Texas Department of Housing and Community Affairs

Presentation, discussion, and possible action regarding a Material Amendment to the Housing Tax Credit Application for Amarillo Lofts (HTC #26189)

AMARILLO LOFTS

RE: **Material Application Amendment Request — Modification of Residential Density**
Amarillo Lofts · TDHCA File No. 26189 — 6601 Lowes Lane, Amarillo, Texas 79106
2026 Competitive (9%) Housing Tax Credit — Awarded; Commitment Notice not yet issued

Original Site Plan

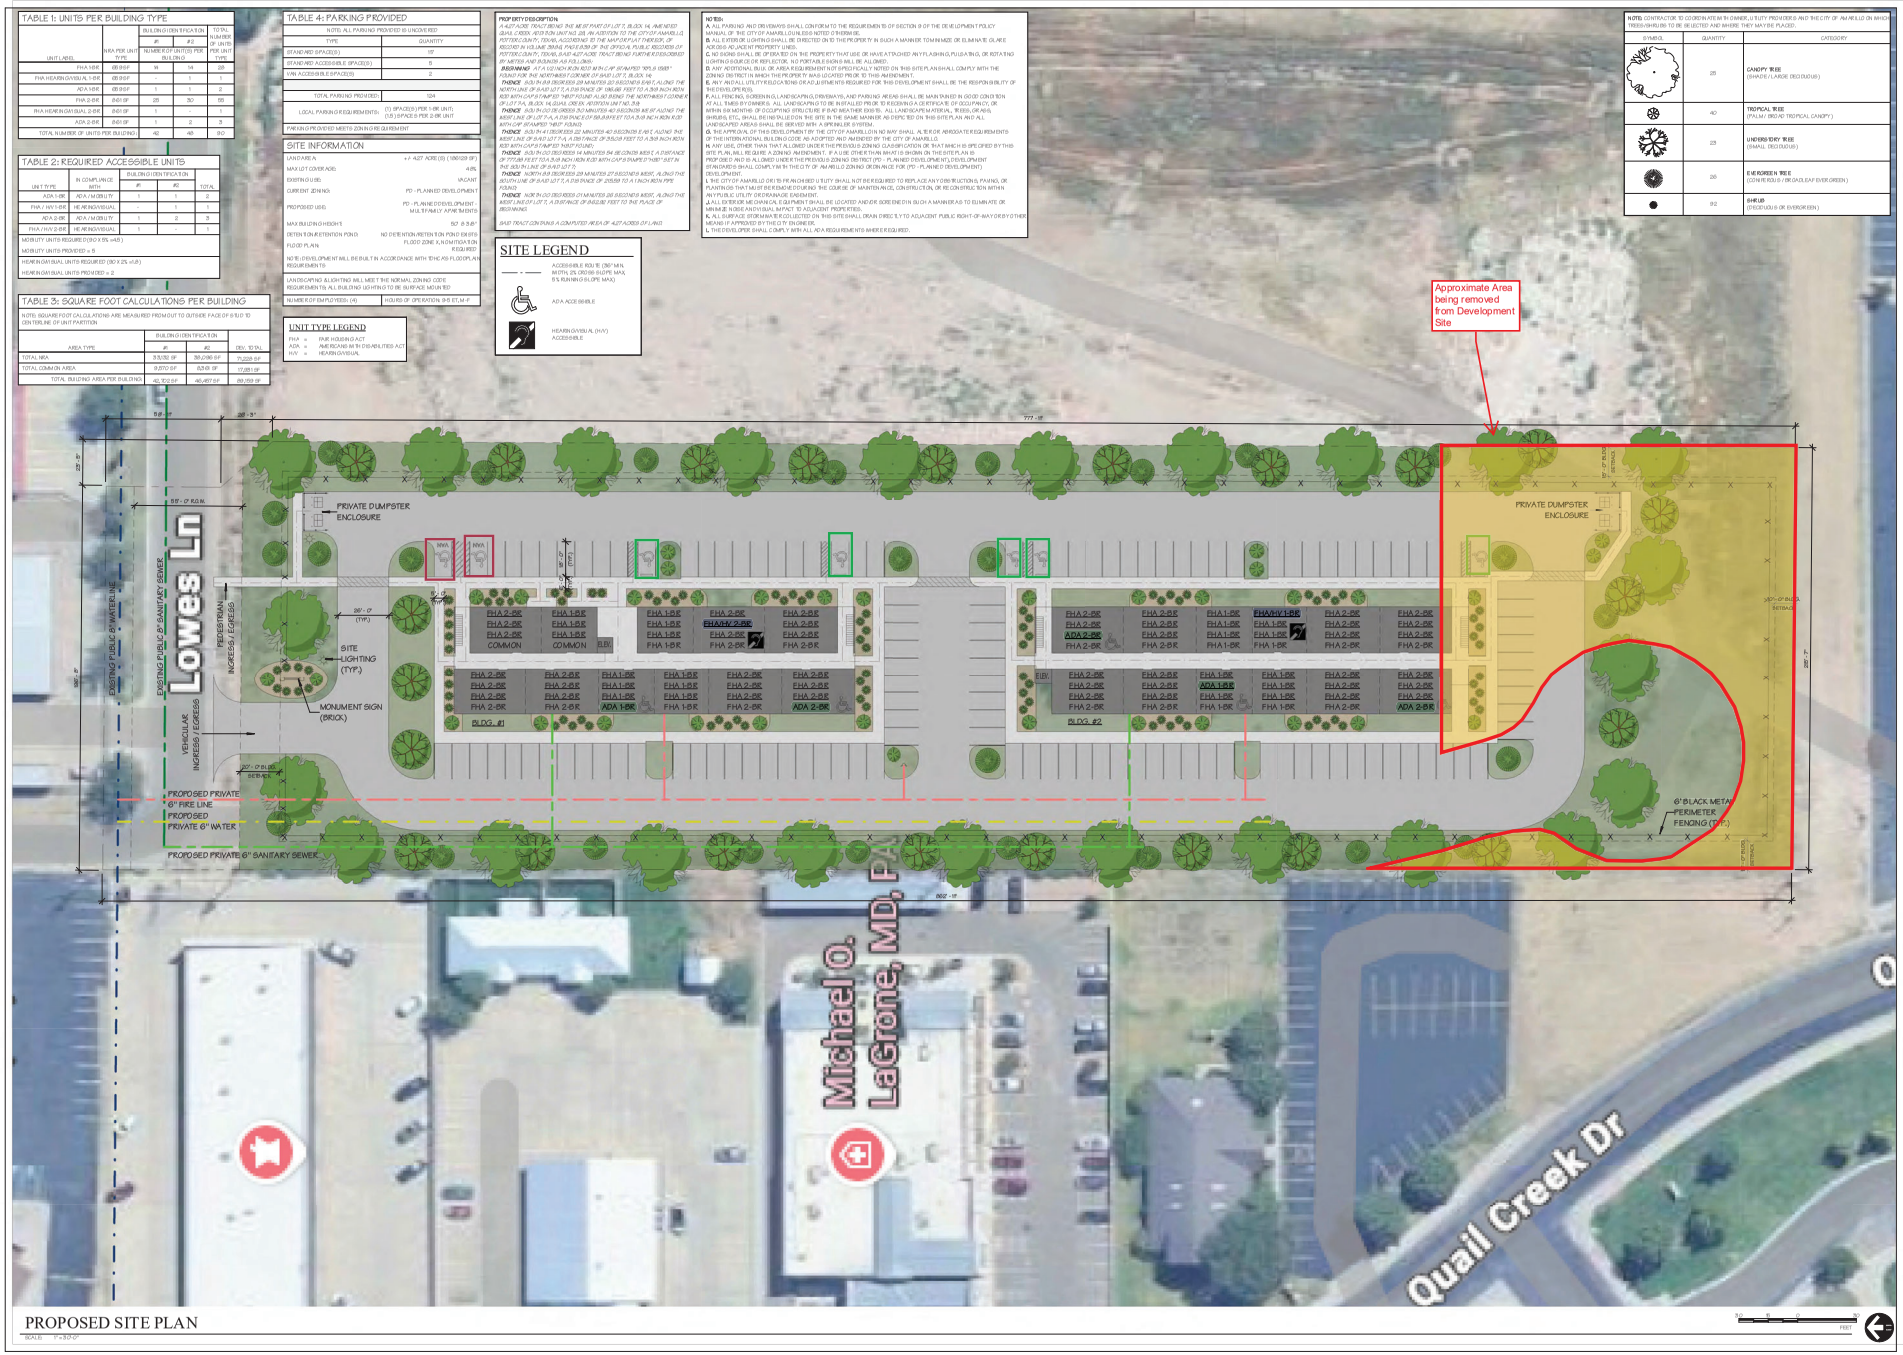
WHEREAS, Gyani Capital (Development Owner or Owner) requests approval to reduce the size of the development site from 4.27 acres to 3.66 acres. The Owner has provided a revised site plan based upon the deduction.

to give up 0.61-acre drive aisle corridor for ingress and egress to the remainder, which reduces the Development Site from 4.27 acres to 3.66 acres, while increasing the residential density by 16.67%.

In short: the City of Amarillo will not approve a plat that leaves the seller's 1.988-acre remainder tract without legal access. Curing that objection requires the Owner to give up a 0.61-acre drive aisle corridor for ingress and egress to the remainder, which reduces the Development Site from 4.27 acres to 3.66 acres and **increases residential density by 16.67%**. The amendment requires no additional Housing Tax Credits, and does not change the total Unit count, the bedroom mix, the Unit sizes, the Net Rentable Area, the building floor plans, the Unit floor plans, the income or rent targeting, the Target Population, the land cost, the Total Development Cost or the Development's self-score. It is required by a municipal platting requirement of which the Owner was unaware at Application.

The Development Site has at all times been a portion of a larger parcel. The Application proposed a 4.27-acre Development Site carved from a 6.2580-acre tract in single ownership, leaving a 1.988-acre remainder to the seller. The amendment reduces the Development Site to 3.66 acres; the 0.61 acres released becomes a drive aisle corridor serving the remainder.

Item	Application (as awarded)	As Amended	Change
Development Site	4.27 acres	3.66 acres	(0.61) acres / (14.29%)
Residential density	21.08 Units/acre	24.59 Units/acre	**+16.67%**
Land area per Unit	2,067 SF	1,771 SF	(14.29%)
Total Units	**90**	**90**	**—**
Site plan	As submitted	Revised	Reconfigured around the corridor

The Owner revised the Development Site accordingly. A 0.61-acre corridor along the Southwest boundary is released to provide ingress and egress to the remainder via an access easement that will be located on the Development site. The Development Site is reduced from 4.27 acres to 3.66 acres. The site plan was revised to reorganize drives, parking and building placement around that corridor. **The number of residential buildings, the building footprints, the building floor plans and the Unit floor plans did not change.** No Unit was moved, resized, added or removed. The revised site plan is enclosed at Tab 3.

Tab 3 Revised site plan — 3.66-acre Development Site, showing the drive aisle corridor serving the 1.988-acre remainder

Tab 4 Site plan as submitted with the Application, for comparison
